Village of Mukwonago REGULAR PLAN COMMISSION MEETING

Notice of Meeting and Agenda *Tuesday, August 13, 2019*

Subject: Great Life / Conditional Use and PUD request and subsequent Site Plan Request

GreatLife Mixed Use Development & Senior Community – Plan of Operation
RE: Site Plan, Architectural, and Planned Unit Development (PUD) Application
Lot 3, CSM 10881 (Greenwald Family Partnership Current Owner) - 255 E Wolf Run
Mukwonago, WI 53149.

GENERAL NOTES

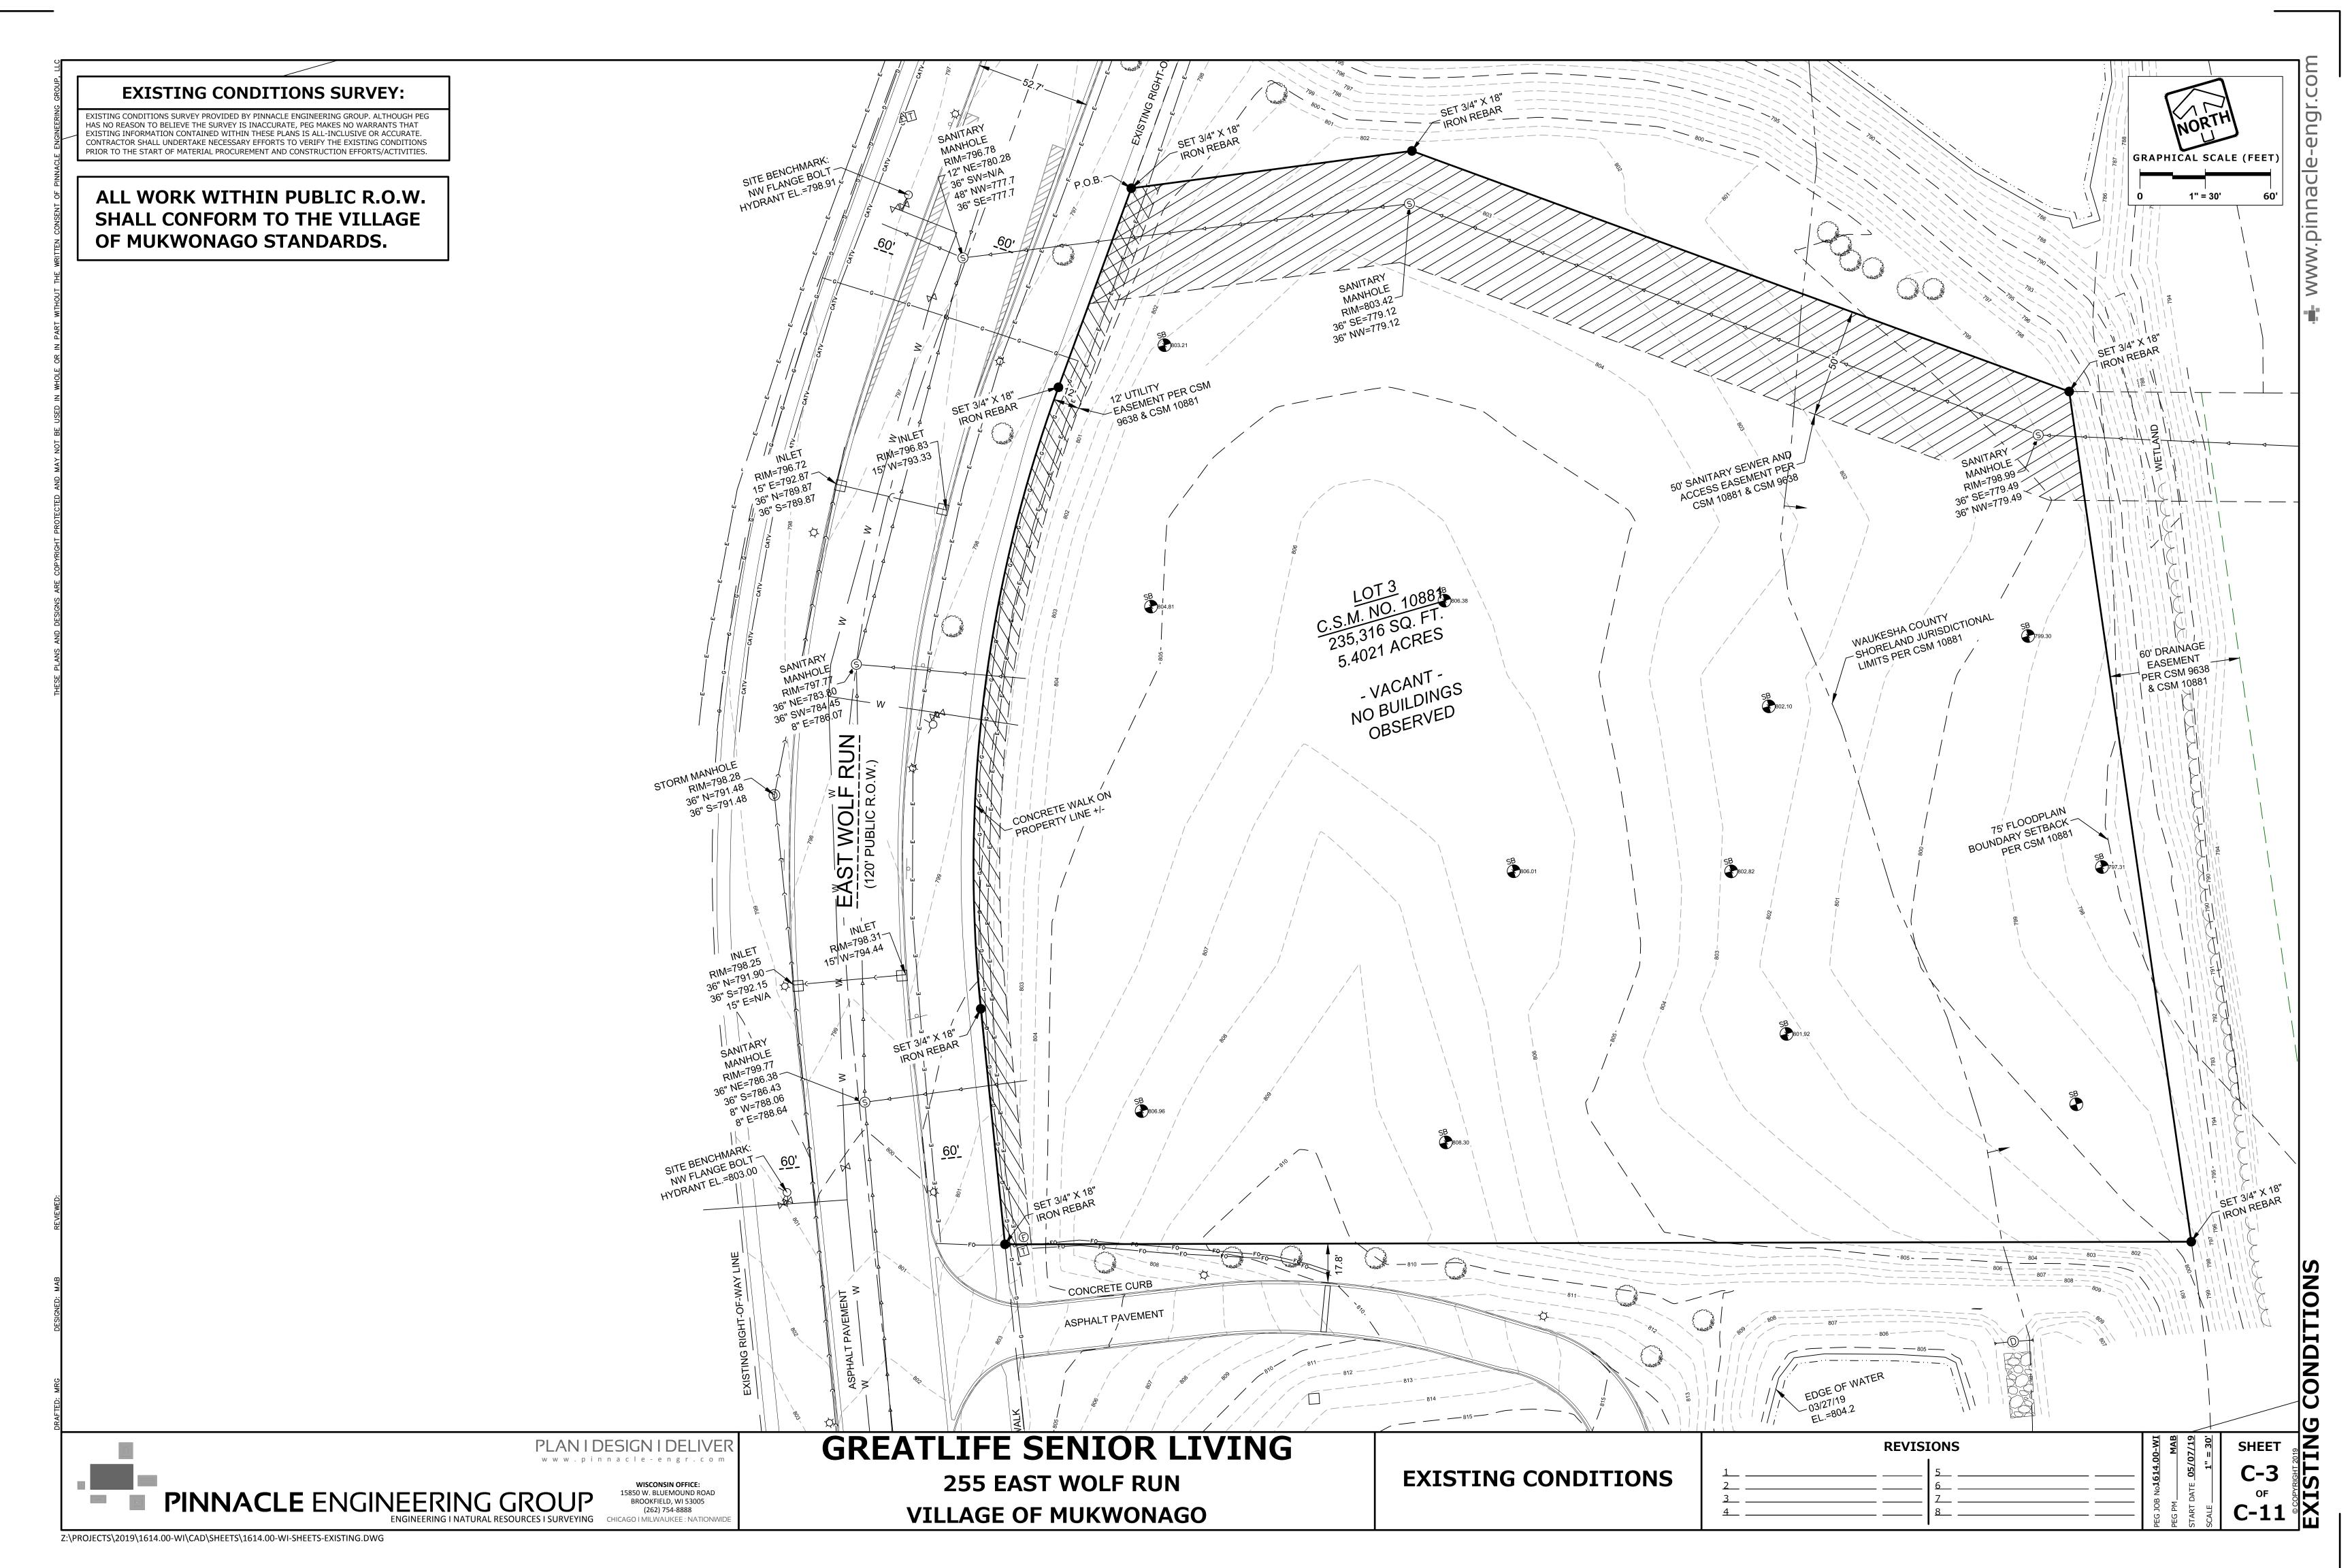
- 19. On sheet C-2, under the "Construction Site Sequencing", provide for a modification of the final note to include that modification to the construction site sequence requires approval by the Village of Mukwonago. Items such as grading and utility installation may occur concurrently, but this should be stated as such rather than allowing the Contractor to modify the order of all items after the installation of erosion control devices. Developer shall include more detail for item 3 of the sequence or separate out activities to ensure that any sediment basins are constructed prior to any grading taking place on the site.

- 4. On Sheet C-2 General notes:
 - a. No.8. Add the word "Utilities";
 - b. No. 16. Replace the words Pleasant Prairie with Mukwonago.;
 - c. No. 17. Manhole frames need to meet village spec. and the wrong spec is given.

255 EAST WOLF RUN VILLAGE OF MUKWONAGO SITE DIMENSIONAL AND **PAVING PLAN**

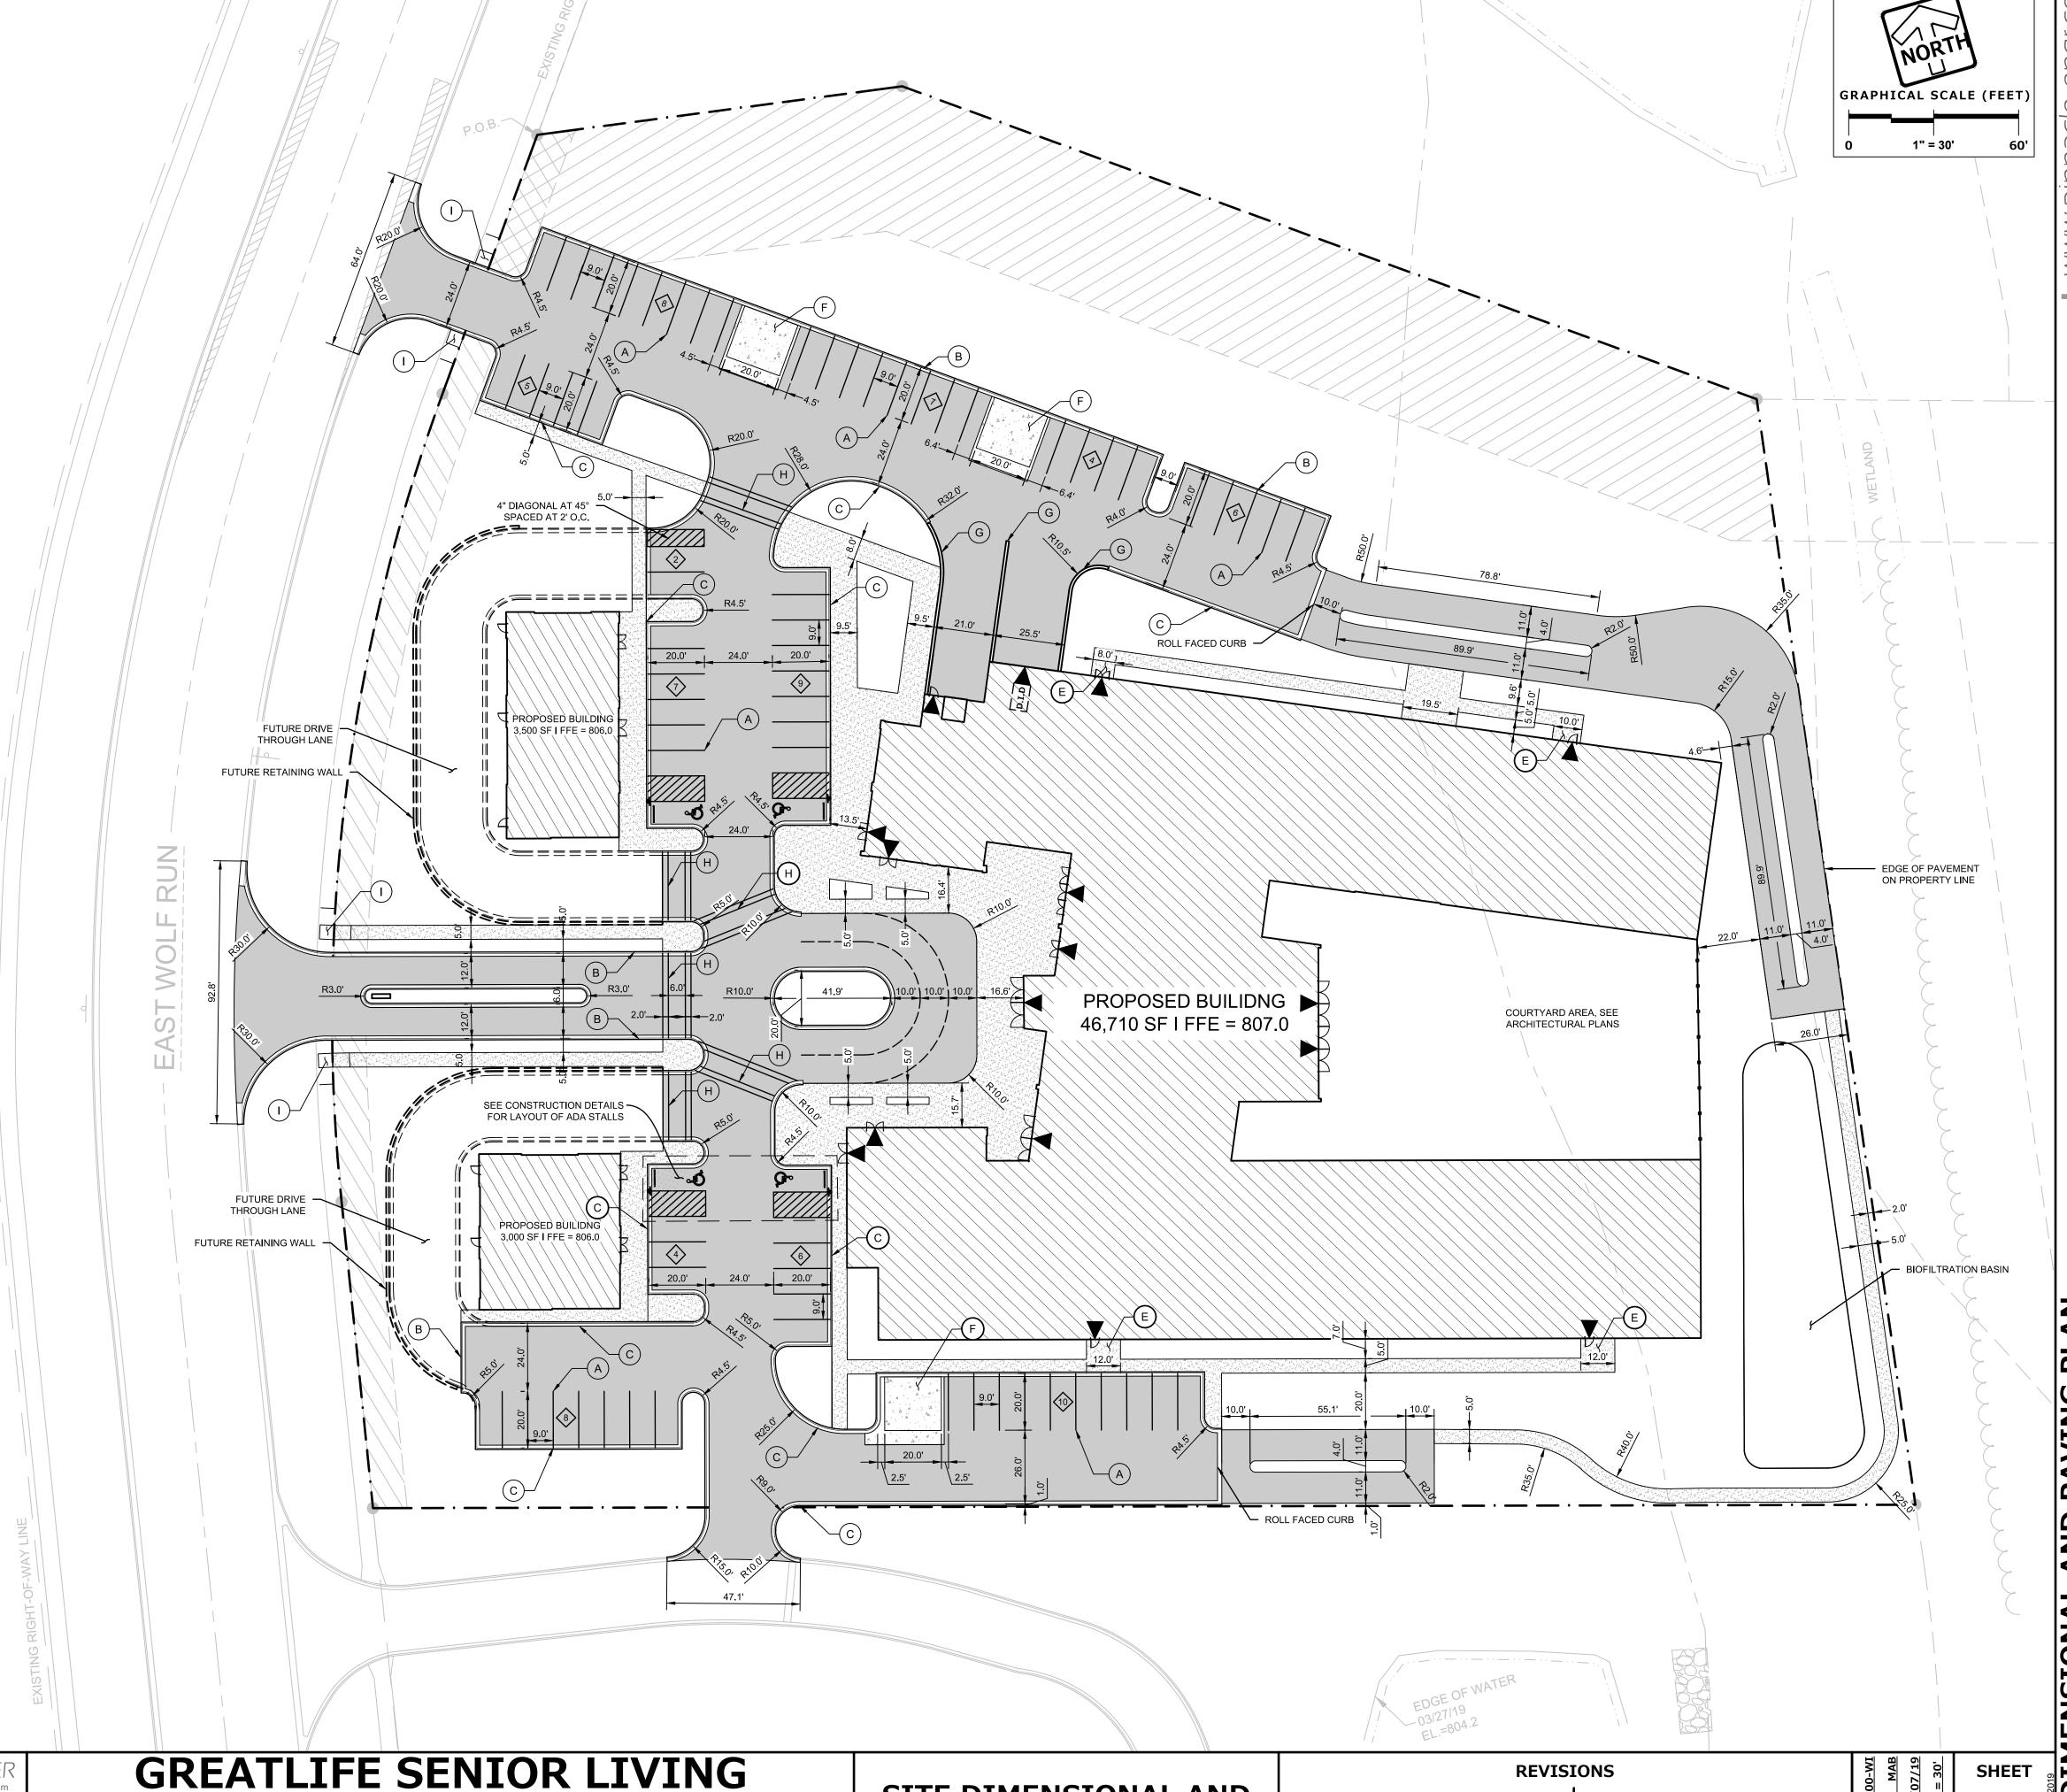
- 20. On sheet C-4, the site layout and pavement design shall be modeled with a WB-50 turning template to verify that the fire departments largest vehicle will have access to all portions of the site. If this requires modifications to the site layout, the storm water practices will need to be addressed for accuracy and compliance with the Village's Ordinance.
